City of Portland, Maine - Building or Use Permit Application

Proposed Project Description:
build a four season sun room, replacing existing deck

Dept: Building **Status:** Approved with Conditions **Reviewer:** Jeanine Bourke **Approval Date:** 12/06/2005

Note: 10/12/05 left msg w/wintergreen for Lew W. To call for details on deck. He called back w/some details, but will email pics on existing deck as the plan is standard and not what is currently built. Received pics but still need beam dimension and joists.
12/5 Melanie called from Wintergreen on status, she emailed pics again.
12/6 spoke w/Don G. And he will provide dimensions
Don G. Called back w/information as noted on plans, ok to issue

WinterGreen Solariums 536 Riverside Street Portland, Maine 207 797-3778		PROJECT
	Standard Post / Deck System Schematic	Date / /

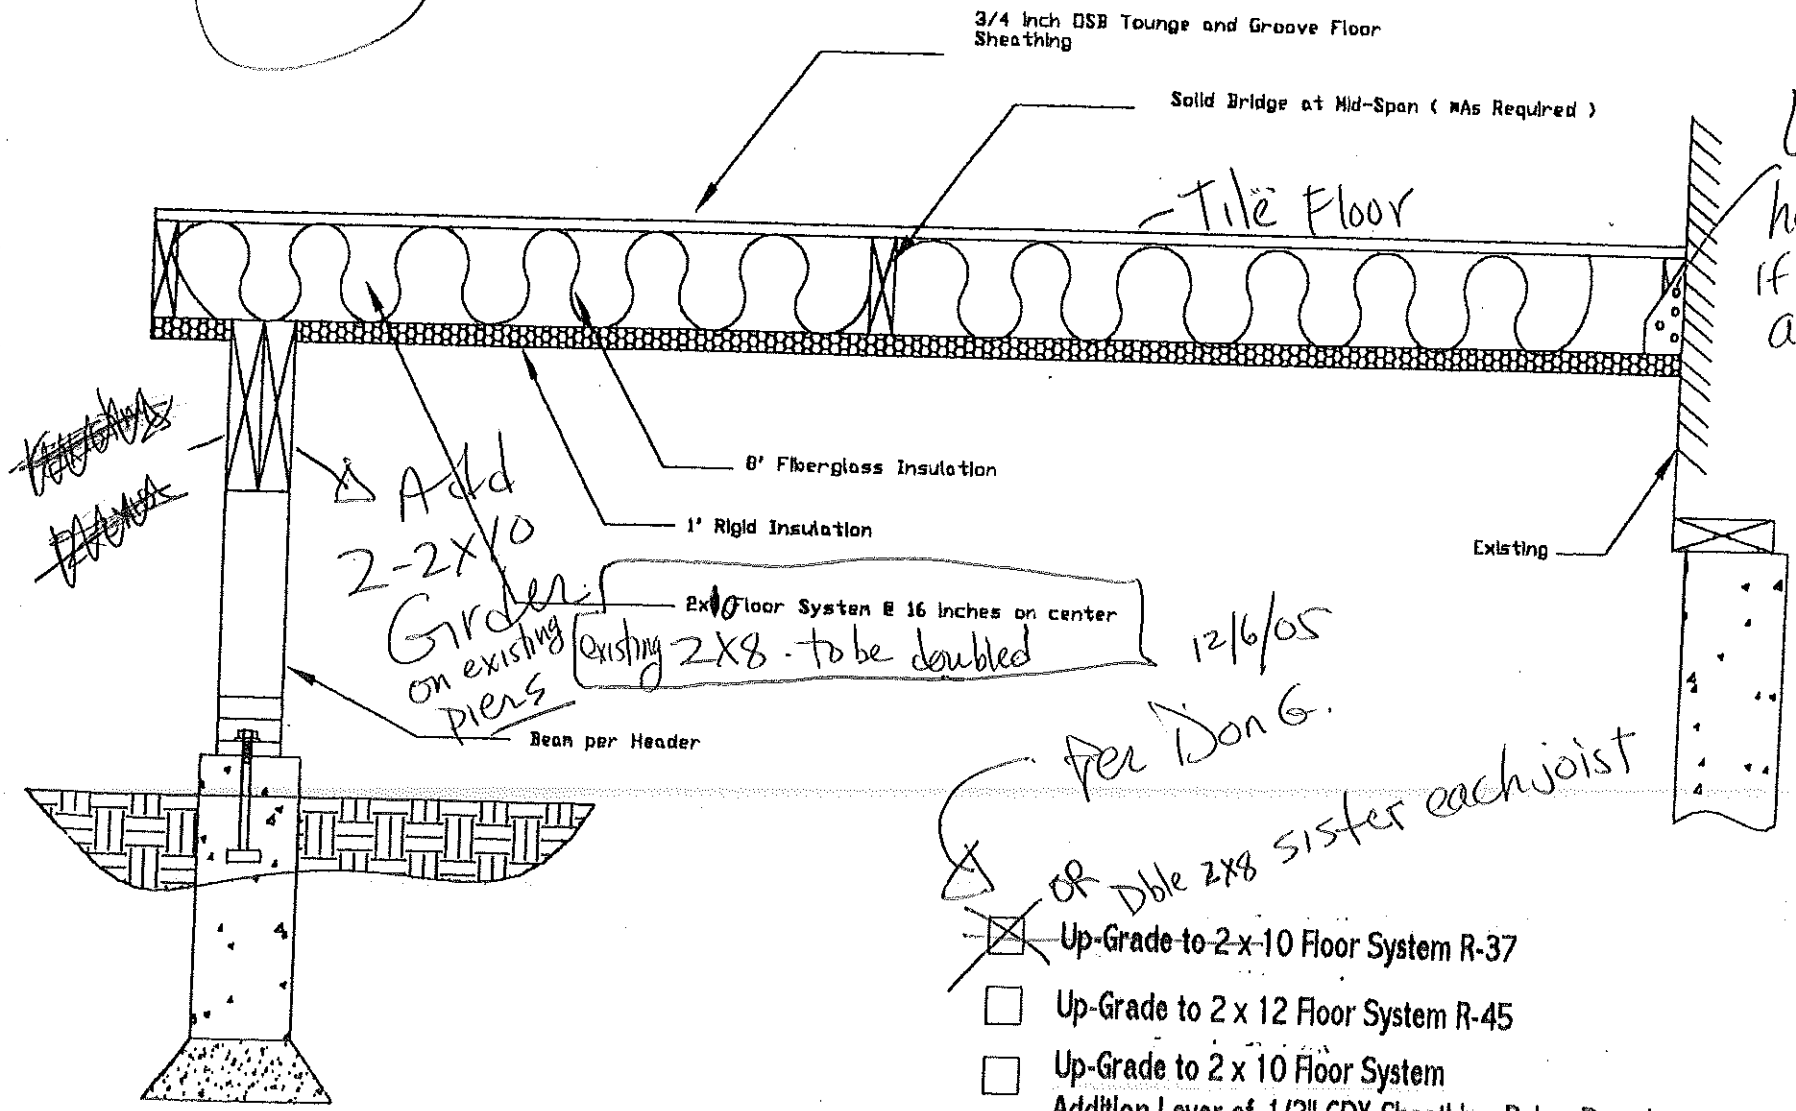
1) Separate permits are required for any electrical, plumbing, or heating.
2) Permit approved based on the plans submitted and reviewed w/owner/contractor, with additional information as agreed on and as noted on plans.
3) The existing deck shall be inspected for adequate fasteners and bearing for spans, and modifications may be required

new pier

add post that matches existing

10/12/05 per Lew W.
